GW - 33

**GENERAL
CORRESPONDENCE**

Subject: Discharge Plan for San Juan River Plant, Non-contact Wastewater

ADDENDUM TO:
RESPONSES TO
SPECIFIC COMMENTS AND INFORMATION REQUESTS
CONCERNING THE WASTEWATER LAND APPLICATION PROJECT
at the
EL PASO NATURAL GAS SAN JUAN RIVER PLANT

FIGURE A. VOLUMETRIC MOISTURE CONTENT VERSUS DEPTH FOR YEARS 0-15 AS PREDICTED BY WORM.

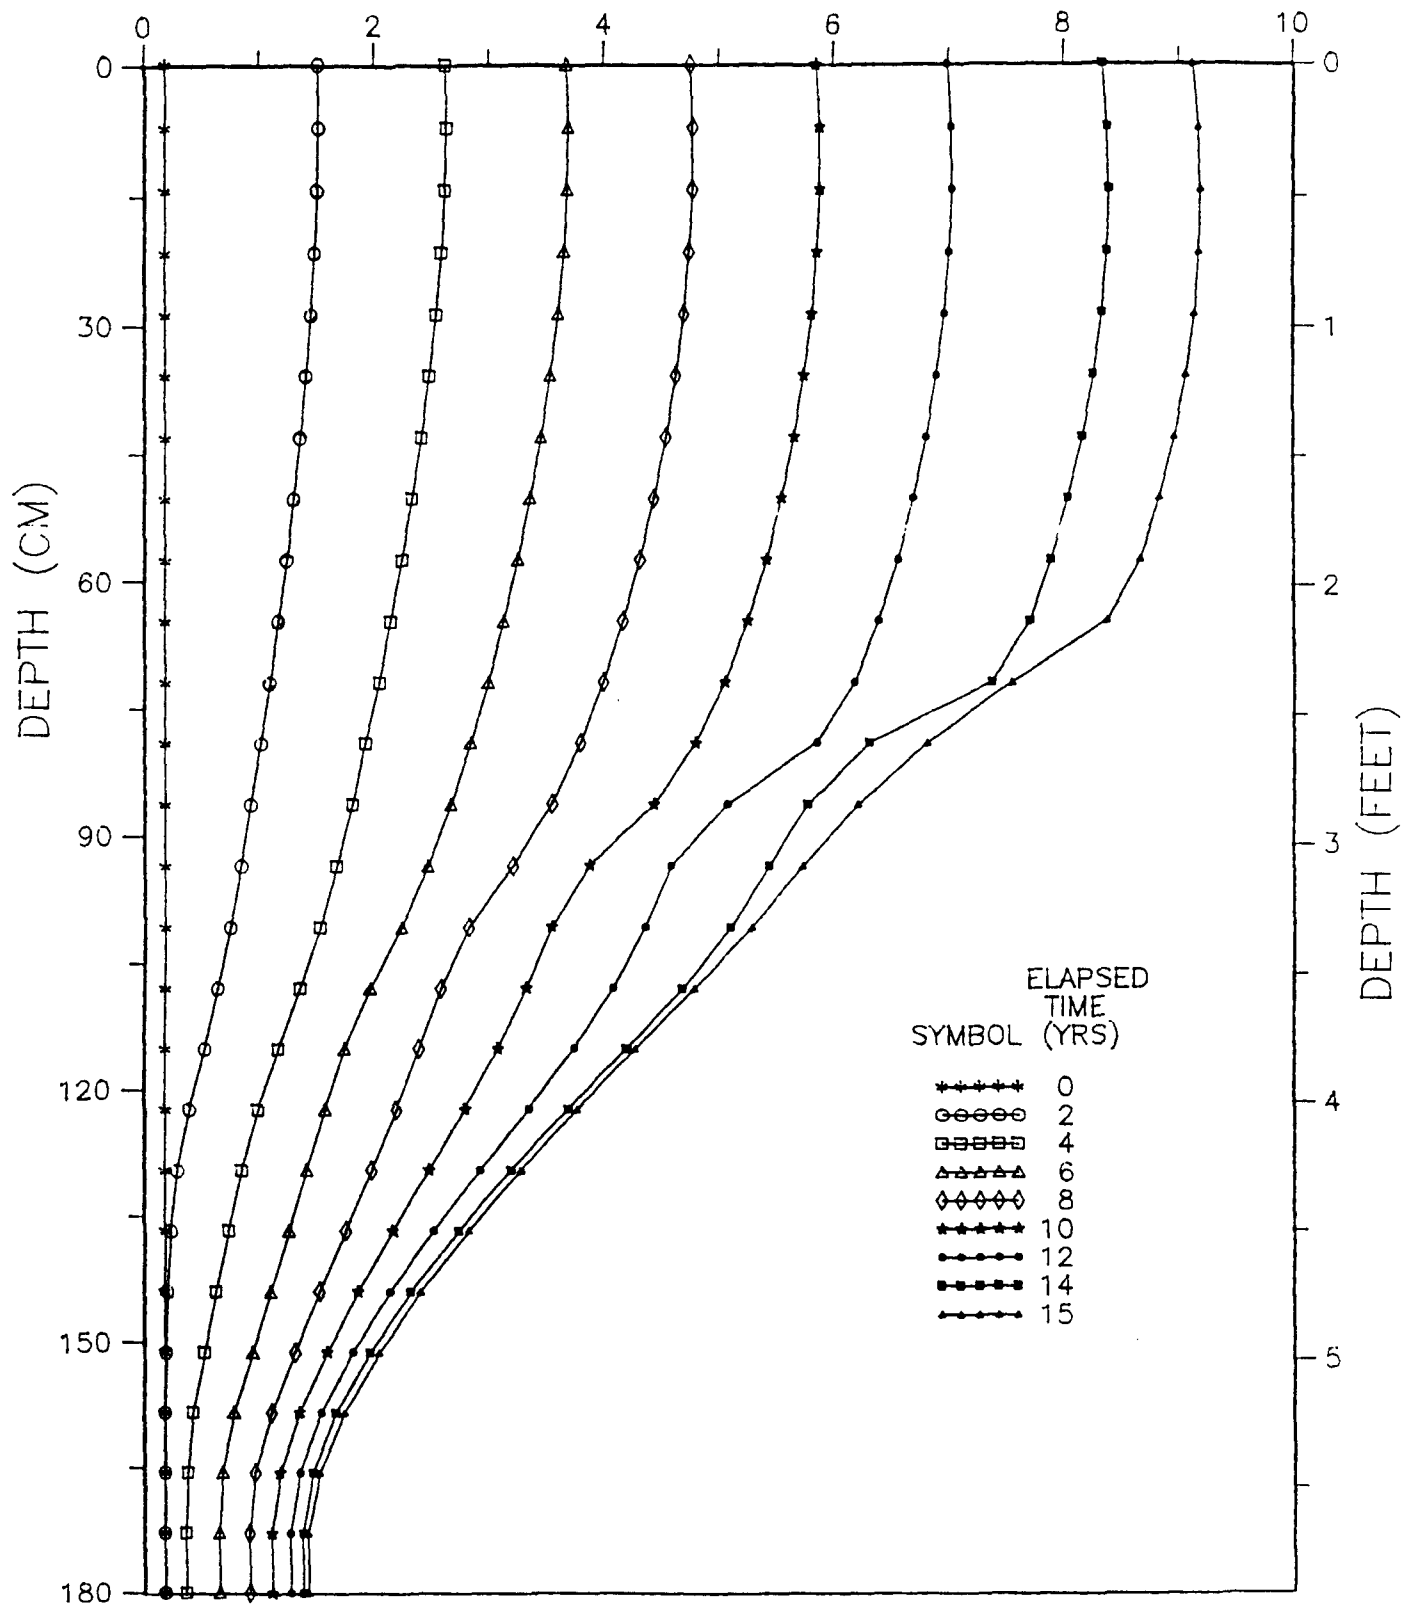
- C.9 As discussed at the April 27 meeting, a vadose zone monitoring plan is necessary to detect a major failure of the system and provide early warning. Information on the type of system, location, proposed monitoring frequency, etc. needs to be provided. Would such a system be able to measure or provide information on soil EC in addition to changes in moisture content?

With the exception of averaging two months values to generate climatic data, none of the input model constraints were altered from those presented in the first set of responses. The result of this latest modeling effort is graphically presented in Figure A (attached). Figure A corresponds to Figures 2 and 3 from the first round of responses. Comparison of these graphs reveals that slight differences are present. However, the magnitude of the differences are small and the overall conclusion presented is essentially unchanged. The differences realized between the two separate modeling efforts are attributed to variations resulting from averaging data.

redistribution over a 15-year period, it is anticipated that volumetric soil water contents will be too low to allow collection of soil-pore liquids using conventional porous ceramic lysimeters or pan-type collection devices in the unsaturated zone. Therefore, the automated soil moisture measurement system will be the sole UZM monitoring system. In the event that soil moisture potentials increase to higher levels than expected during the life of the wastewater irrigation project (indicating early breakthrough of soil drainage water and dissolved solutes), porous ceramic lysimeters can be retrofitted to attempt collection of soil-pore liquids, or soil cores can be taken in the unsaturated zone to verify and quantify the magnitude of downward salt movement below the irrigated fields.

FIGURE B. GROUNDWATER MONITORING SYSTEM.

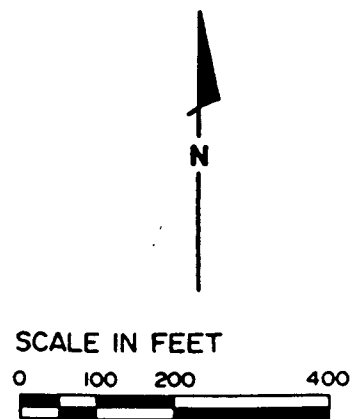
- C.2 p.13 Provide the proposed location of the additional monitoring wells to be installed.

C.2 p.13 Provide the proposed locations of the additional monitoring wells to be installed.

Response: Figure B illustrates the locations of monitoring wells to be installed at the site to complete the groundwater monitoring system. The selection of the locations for these wells is based on the groundwater flow direction, controlling features of the local geology, and the desire to use existing monitoring wells which were installed during the feasibility study. Three new monitoring wells will be installed (MW-4, MW-5, MW-6) and MW-3 will be retained as an active well for the land application project. This configuration places three wells in downgradient locations and one well upgradient of the land application areas.

Additionally, all of the monitoring wells and piezometers not designated for groundwater sampling will be used to measure the depth to water during the active life of the land application project. Depth-to-water measurements from all monitoring wells and piezometers will provide a clear picture of the groundwater contours at the site.

Figure 1. Monthly Distribution of Crop Coefficients for Tall Fescue.

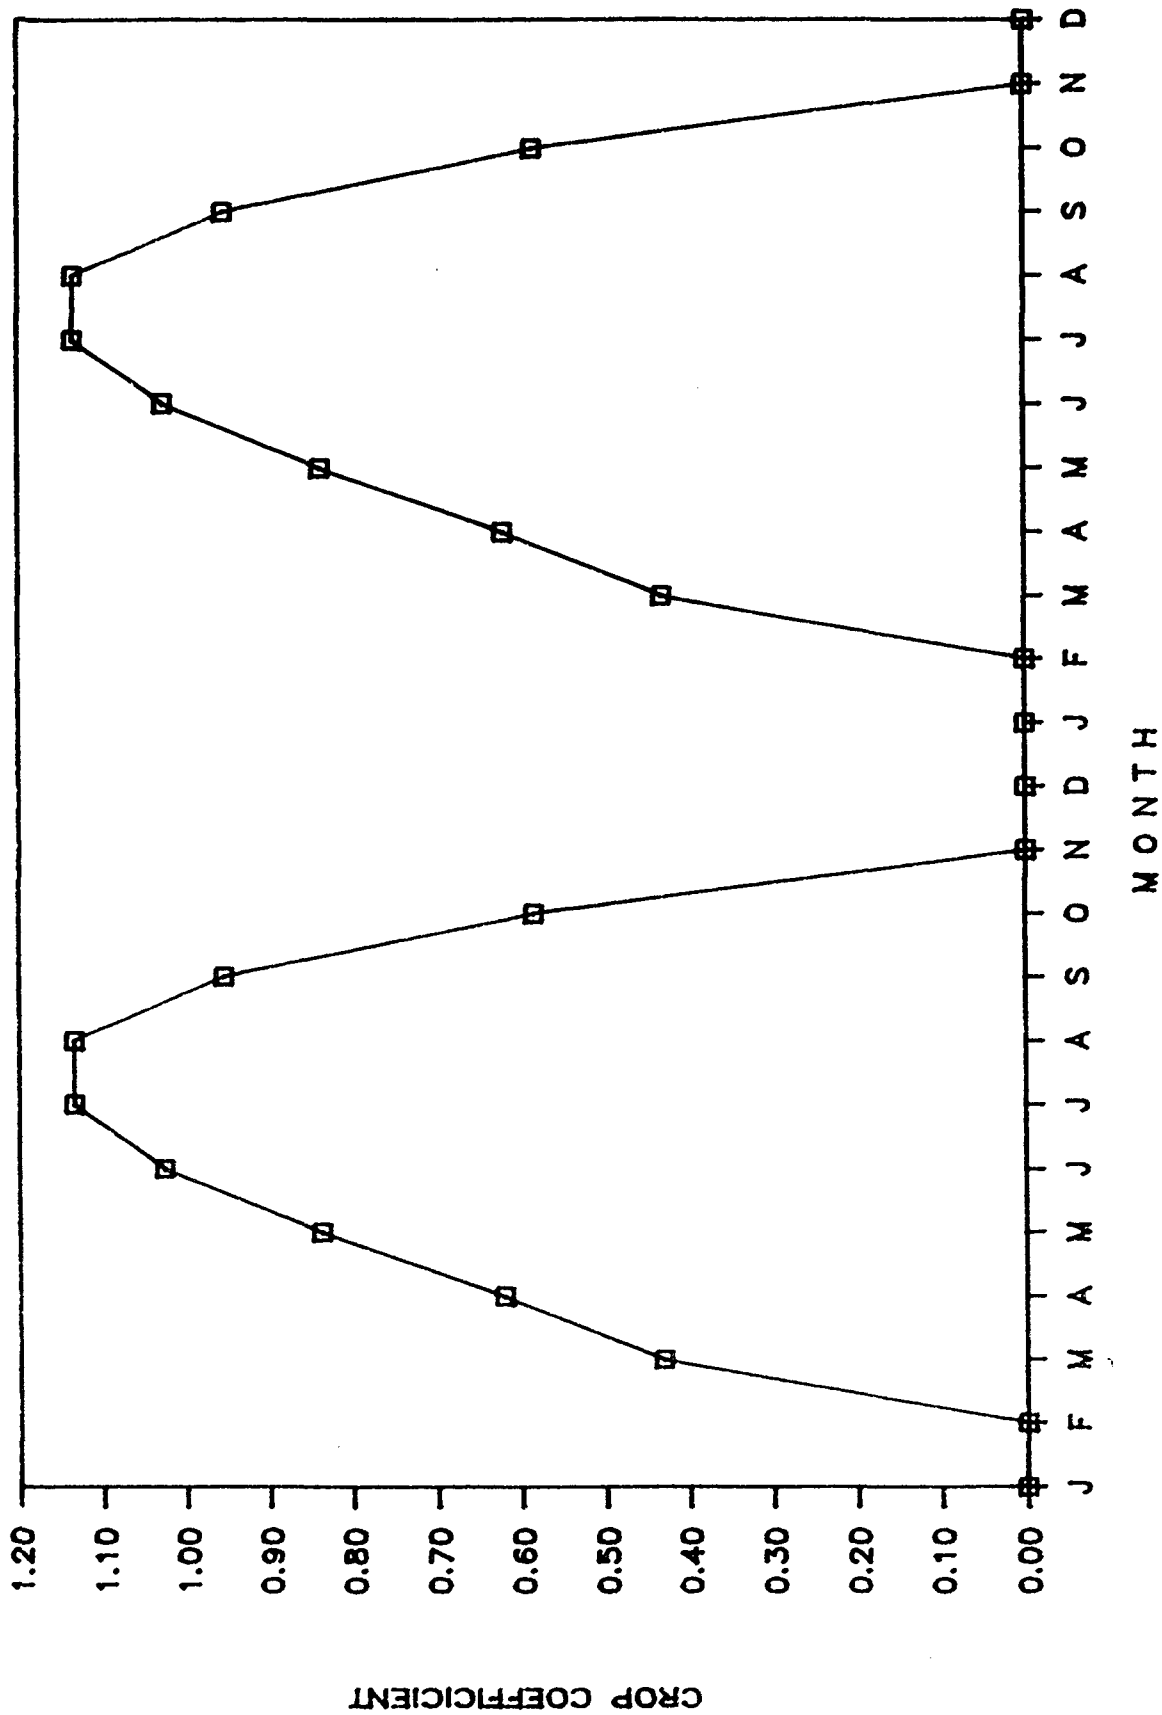
- A.3. P. 79, Phase I; P. 7 D.P.: If native vegetation is to be irrigated, the proposed application rates that are shown in Table 4.7, p. 36 (Phase II report) will drown the native plants present on the most heavily irrigated acreage. Different vegetation species (e.g. hay, alfalfa) must be planted if application rates are heavy. If rates are lowered to grow native species, "nuisance" species such as tumbleweeds must be avoided. Notwithstanding the above, salt impacts due to leaching must be considered as discussed below.

The seasonal distribution of mean crop coefficients for alfalfa was obtained from lysimeter trials. The source of these data is the New Mexico State University Experiment Station (Sammis et al., 1985). From this data, a seasonal distribution of the crop coefficient for tall fescue was estimated (Figure 1).

In keeping with the methodologies employed by Sammis et al. in developing crop coefficients for plants in the San Juan River area, a third-order polynomial was fitted to the experimentally-generated data. This curve was used to generate monthly values of tall

Figure 2. Volumetric Moisture Content Versus Depth for Years 0-4 as Predicted by WORM.

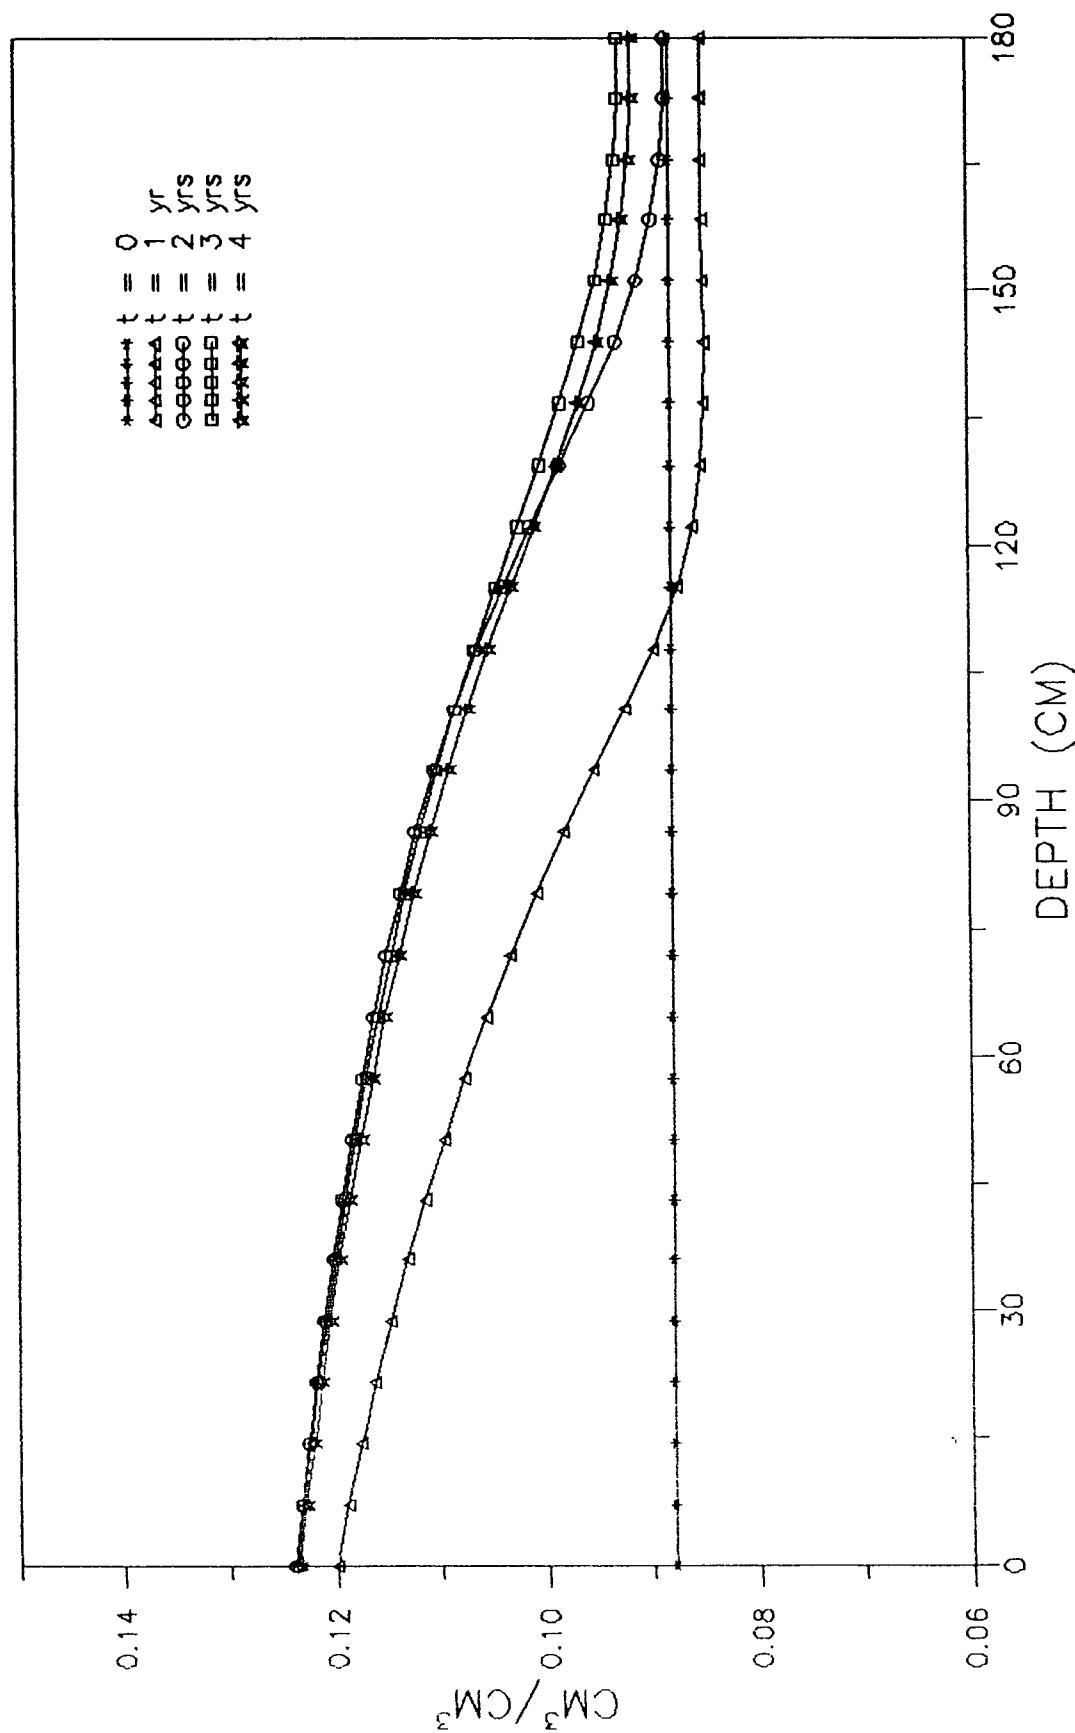
- B.2. Table 4.7 (p. 36) Phase II, p. 3, K. W. Brown attachment to EPNG 12/24/87 letter: The scenario presented in the table estimates more than a foot of water per year being leached to the subsurface on the most heavily irrigated plots. When steady state conditions are attained, that amount will reach the ground water and mound under the site. This will locally change both the direction and magnitude of the local hydraulic gradient causing the poorer quality ground water (with native and added salts) to migrate faster downgradient. The magnitude of these changes (both water movement and concentrations has not been estimated in the reports.

The flow/transport model WORM was run for a period of 8 years utilizing boundary conditions defined on a monthly basis. Figure 2 illustrates the predicted moisture content profile for the upper six feet of soil for years 0 through 4. Year 1 indicates that the upper 110 cm (3.61 feet) of soil has been wetted to levels above the initial moisture content of 8.8 percent. Below 110 cm, the model has shown that an insignificant amount of drainage has occurred (0.089 cm of water has drained after 1 year) as the moisture content has fallen below the initial value; this amount of drainage pales in comparison to the total amount of water applied (18.50 cm), and the total amount of water removed via evapotranspiration (18.88 cm).

The convergence of moisture curves for years 2-4 suggests that steady-state conditions are developing within the upper six feet of soil; Figure 3 tends to support this claim. A closer comparison of Figure 3 with Figure 2 indicates that the soil is becoming drier with time. At 180 cm (6 feet), the curves are grouped together at
